OIL-OVER-FILLING FIX

If your unit has FMTVs with serial number 100,001 or higher, listen up! Trucks equipped with C7 engines can experience oil blow-by problems due to overfilling.

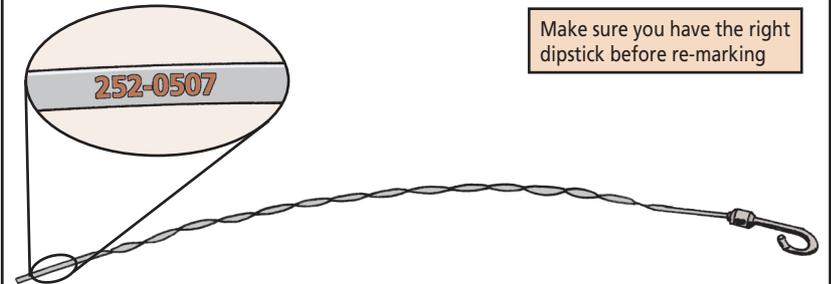
Do not remove engine oil filter while engine is hot. Failure to comply may result in severe injury to personnel.

- Remove and replace the engine oil filter and use Caterpillar oil filter, NSN 2910-01-519-3768, PN 1R1807.
